December 11, 2013

Town of Westwood
Planning Board
Town House
50 Main Street
Westwood, Massachusetts 02052-2009

Re: Life Time Fitness, University Station
Project Development Review (PDR)

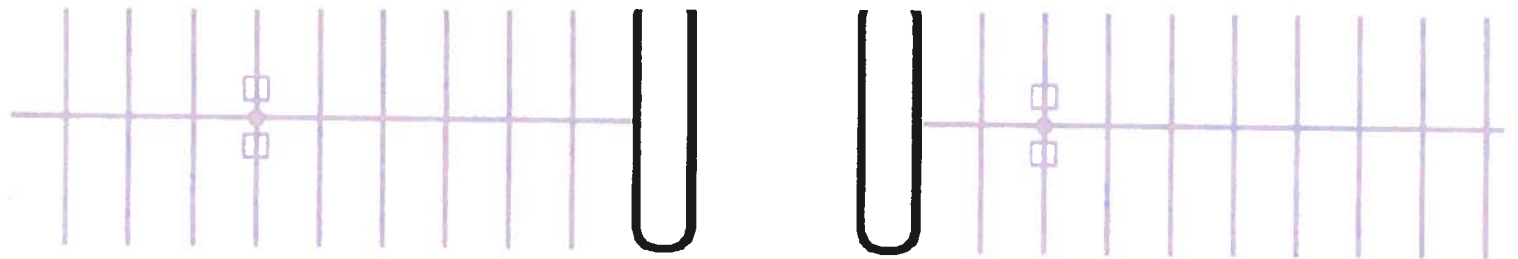
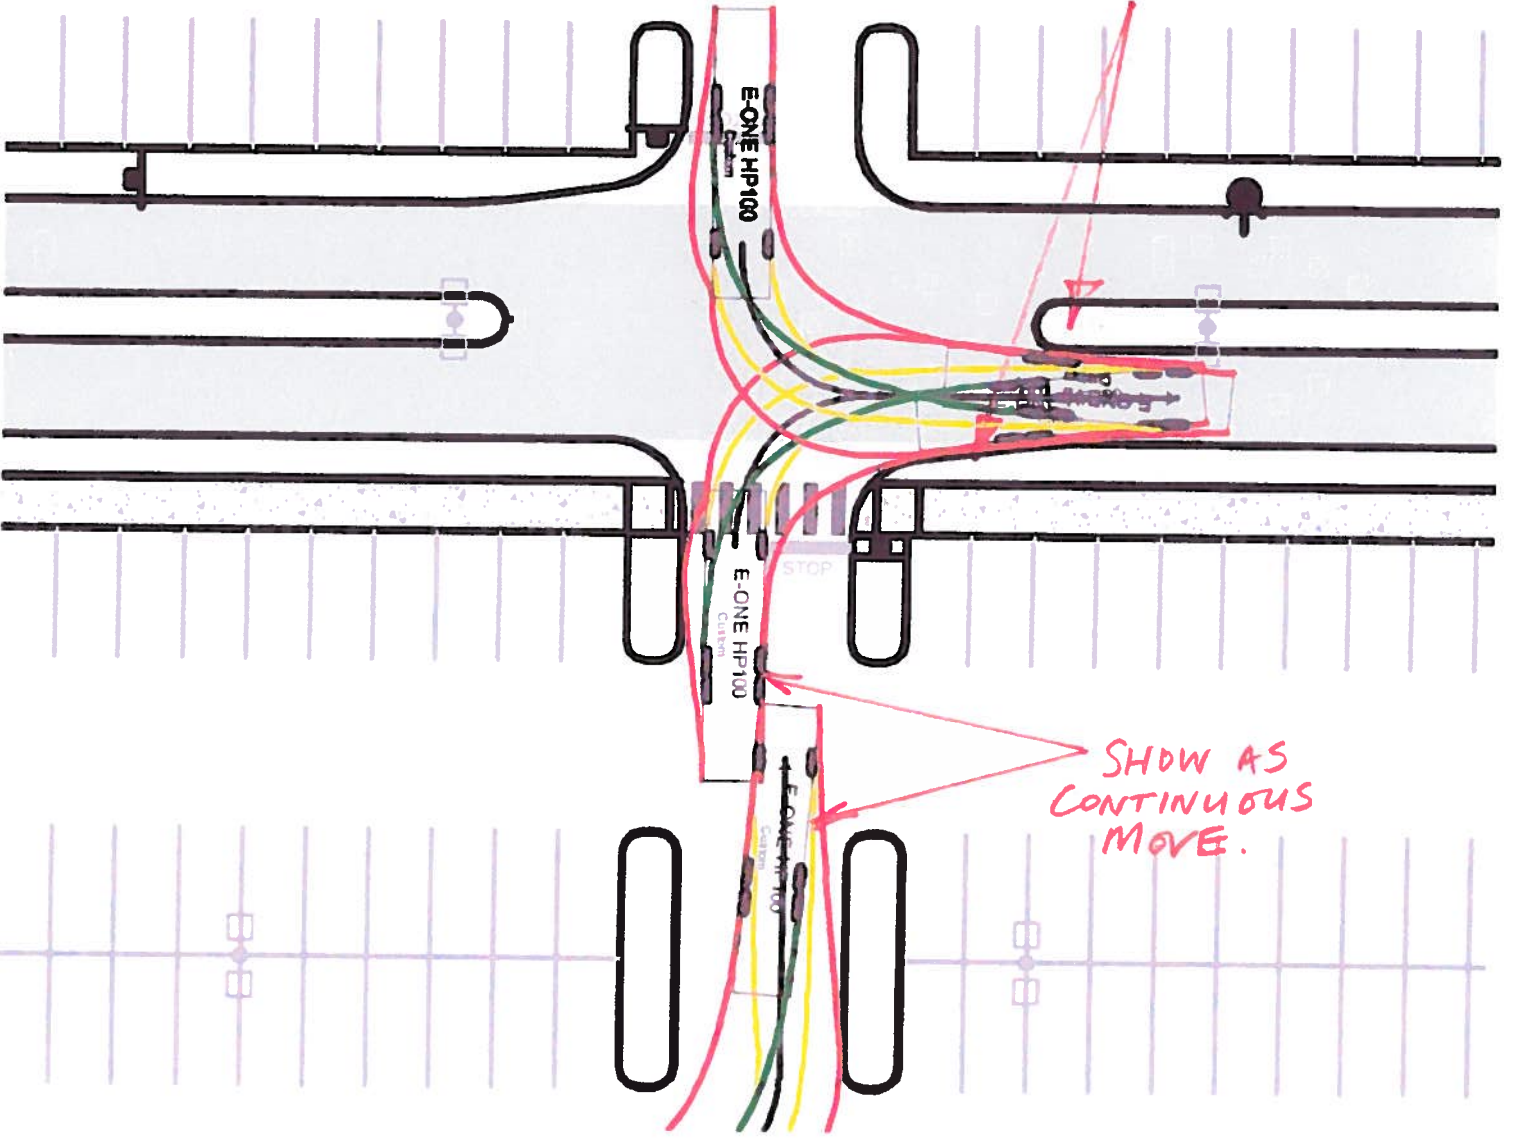
that the site layout can accommodate the turning movements requested by the Fire Chief. S: Fire Chief requested minor revisions see sketches (2) attached.

ADJUST NOSE TO ENSURE MIN 2' CLEAR

SHOW AS CONTINUOUS MOVE.
